REMARKS

IN THE DRAWINGS

FIG.1A PRIOR ART

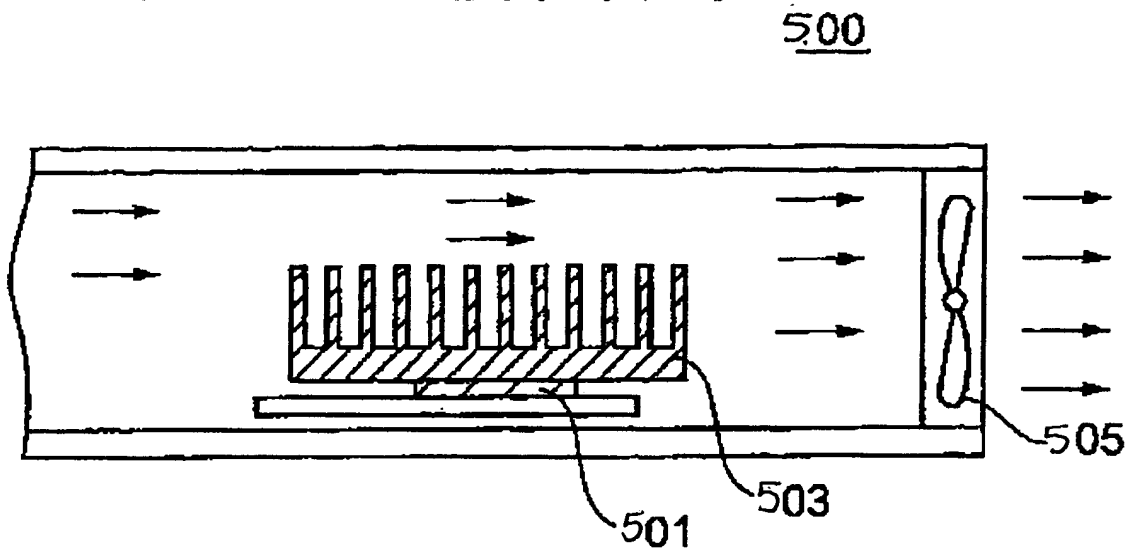
Please approve replacement of FIG. 1A and FIG. 1B with the attached FIG. 1A and FIG. 1B marked in red to reflect the addition of the amount of 400 to each of the reference numbers.
